# UNITED STATES PATENT AND TRADEMARK OFFICE

APPLICATION NO.	FILING DATE	FIRST NAMED INVENTOR	ATTORNEY DOCKET NO.	CONFIRMATION NO.
10/822,255	04/10/2004	David Todd Nay	SJO920030070US1	1765

<b>Office Action Summary</b>	<b>Application No.</b> 10/822,255	<b>Applicant(s)</b> NAY ET AL.	
	<b>Examiner</b> Philip Gabler	<b>Art Unit</b> 3637

## DETAILED ACTION

**FIG. 2**

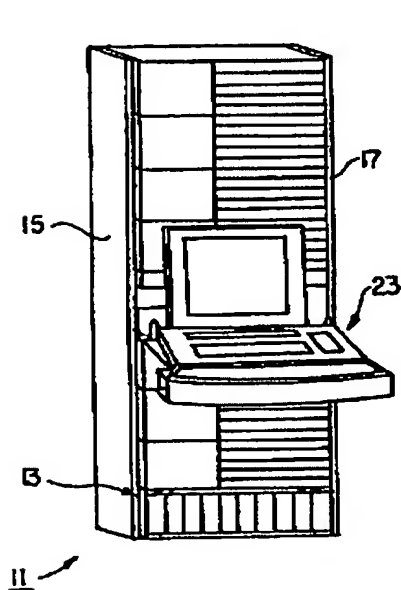
15. Claims 1-20, as best understood, are rejected under 35 U.S.C. 102(b) as being anticipated by Moore et al. (US Patent Number 6201690). Moore (Figures 2, 9-13) discloses a computer terminal bracket (23) adapted for rack mounting and to carry a computer terminal comprising: a keyboard holder (41), wherein the height of the keyboard holder is adjustable in a vertical direction; and a display holder (77), wherein the viewing angle of said display holder is adjustable with respect to a cabinet (13) and keyboard holder.

Moore et al. '690 Figures 10-13

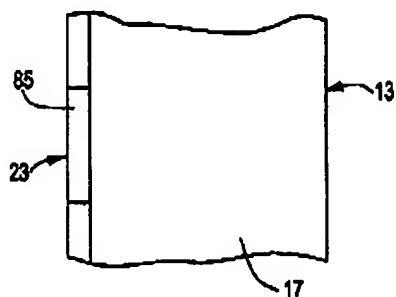
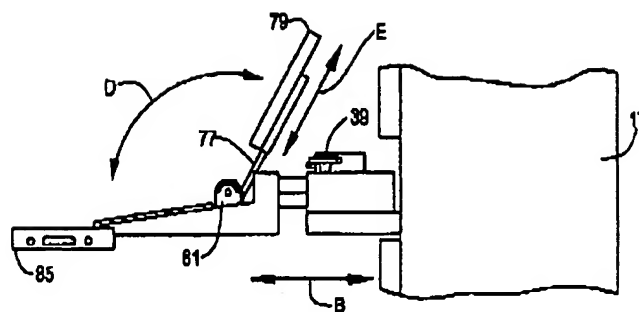
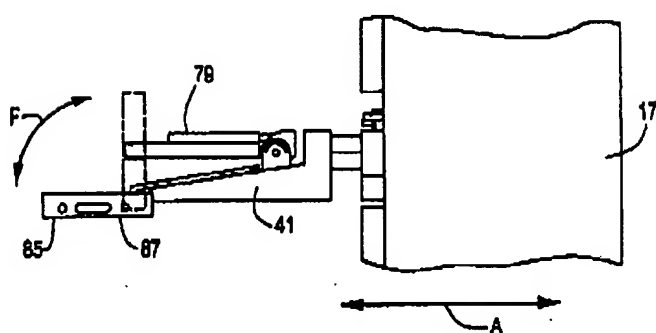
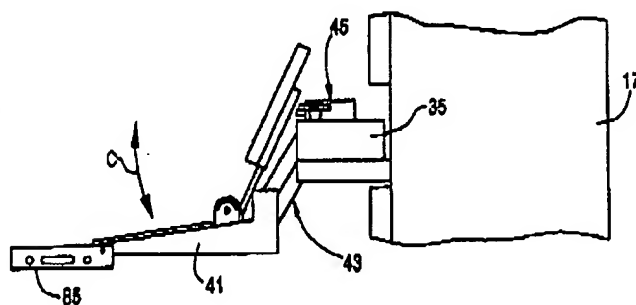
16. Regarding claim 2, Moore further discloses the bracket folds into a single horizontal plane whereby the keyboard holder, display holder, and bracket are coplanar and storable in the cabinet (any number of horizontal planes would pass through all of these elements in their folded position). See Figures 10-12.

18. Regarding claim 4, Moore further discloses a first frame (35) movable with respect to a rack (viewed as cabinet 13) whereby a distal edge region (viewed as A in Exhibit 1) of the first frame of the bracket is extendable outwardly from the rack; and a second frame (43) pivotally mounted at its proximal edge region (B) to the distal edge region of the first frame for vertical movement of the keyboard holder and display holder (see Figures 10-13).

Schairbaum '823 Figure 6

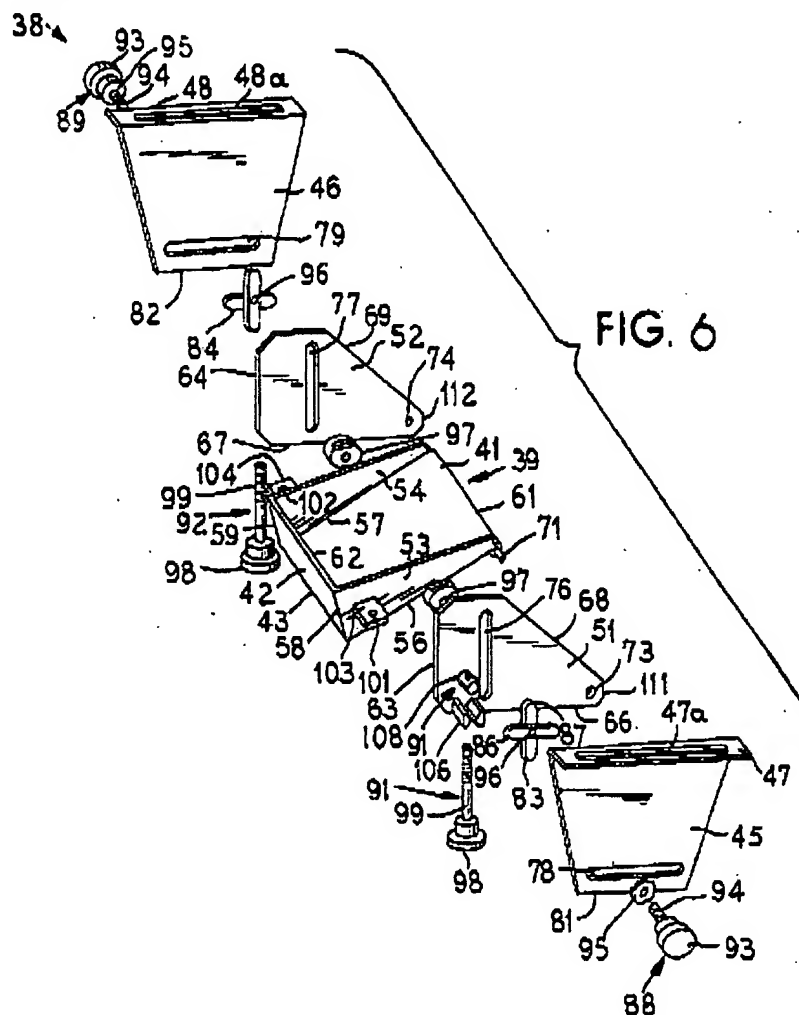
29. Claims 21 and 22 are rejected under 35 U.S.C. 103(a) as being unpatentable over Moore in view of Schairbaum (US Patent Number 5655823). Moore discloses a cabinet as recited in claim 20 but does not disclose a rail or frame with a surface having a low coefficient of sliding friction. Schairbaum (Figure 6) discloses a monitor support

assembly including low sliding friction coefficient slides (83 and 84) for engaging rails (76-79). The slides are preferably made of polypropylene (see column 5 lines 36-39).

Accordingly, it would have been obvious to one of ordinary skill in the art at the time the invention was made to modify Moore's frame to include a low friction surface such as polypropylene as taught by Schairbaum because this would allow the frame to slide more easily on the rail.

Gill et al. '032 Figure 4

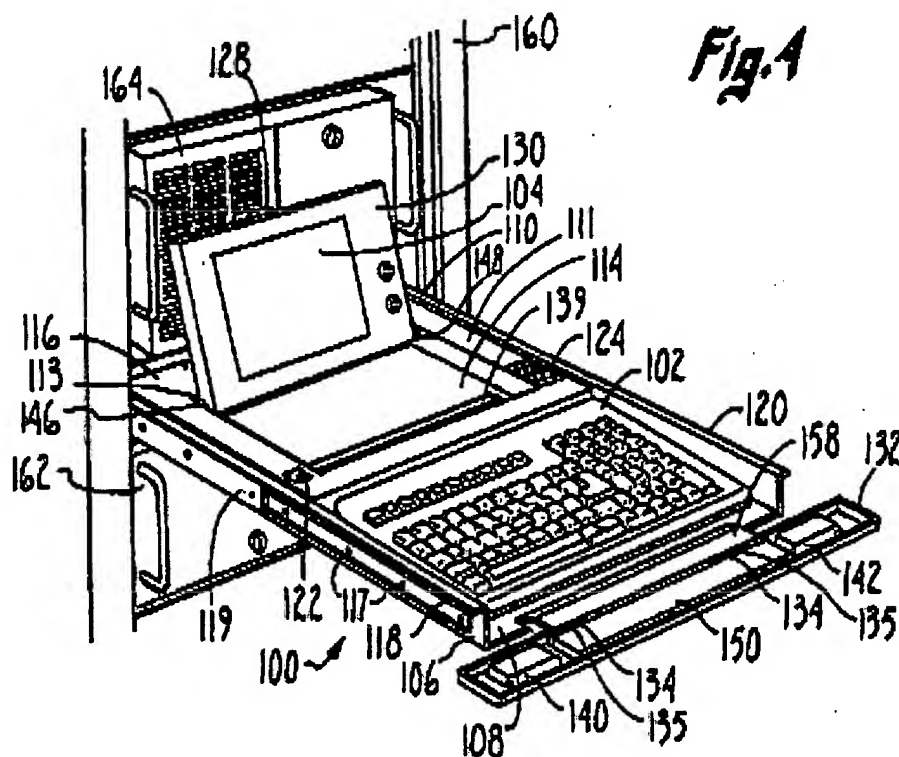
30. Claims 23 and 24 are rejected under 35 U.S.C. 103(a) as being unpatentable over Moore in view of Gill et al. (US Patent Number 5388032). Moore discloses a cabinet as recited in claim 20 but does not disclose a rail or frame comprising a rolling element. Gill (Figure 4) discloses a rack mounted computer terminal including a rail (119) and a frame (118) comprising a rolling element (disclosed as either a wheel or a bearing, see column 8 lines 41-43). Accordingly, it would have been obvious to one of ordinary skill in the art at the time the invention was made to modify Moore's rail or frame to include either a wheel or bearing as taught by Gill because this would allow the frame to slide more easily on the rail.
